Notice of Allowability	Application No.	Applicant(s)	
	10/647,236	LIN ET AL.	
	Examiner	Art Unit	
	Karabi Guharay	2879

Examiner's Amendment

Fig. 5

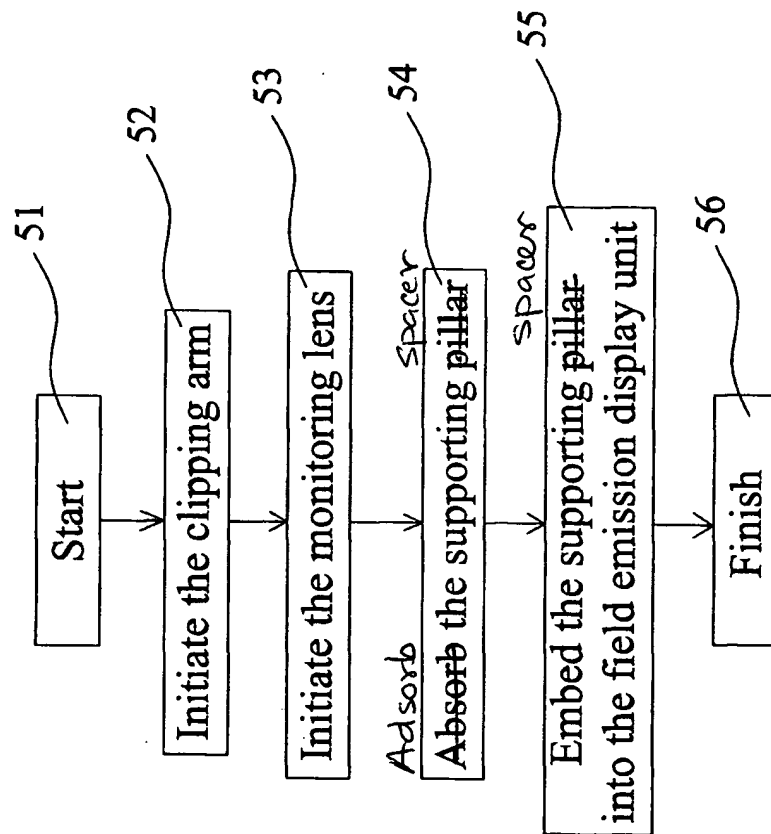
In Fig 5, "Absorb the supporting pillar" has been replaced by -----Adsorb the supporting spacer -----, and "embed the supporting pillar" has been replaced by ----- Embed the supporting spacer-----.
